MIL "ON" DTC P0401

Service Category Engine/Hybrid System

YEAR(S)	MODEL(S)	ADDITIONAL INFORMATION
2011 – 2012	CT200H

Some 2011 – 2012 model year CT 200h vehicles equipped with a 2ZR-FXE engine may exhibit a MIL "ON" condition with Diagnostic Trouble Code (DTC) P0401 (*Exhaust Gas Recirculation Flow Insufficient Detected*) present. The Exhaust Gas Recirculation (EGR) Valve has been improved to address this condition.

Figure 1.

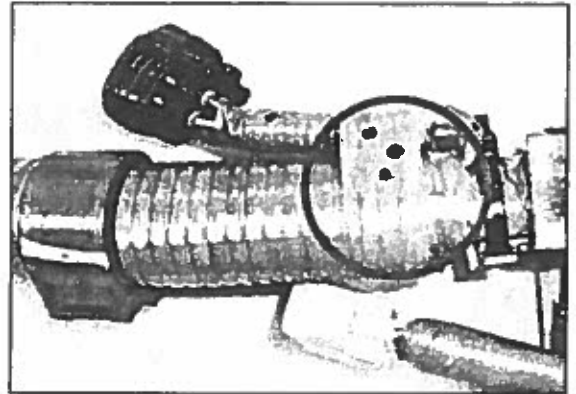
A. Remove the vinyl tape wrapped around the main harness and the EGR harness.

Figure 2.

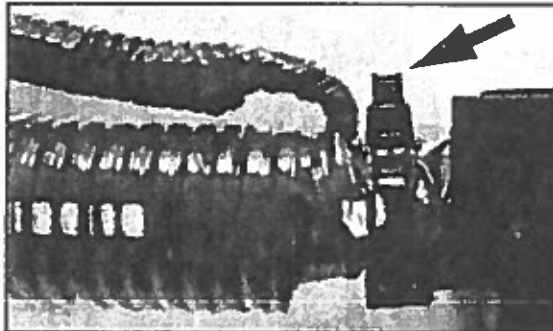
B. Wrap the exposed zip tie 7 – 8 times with the heat-resistant vinyl tape.
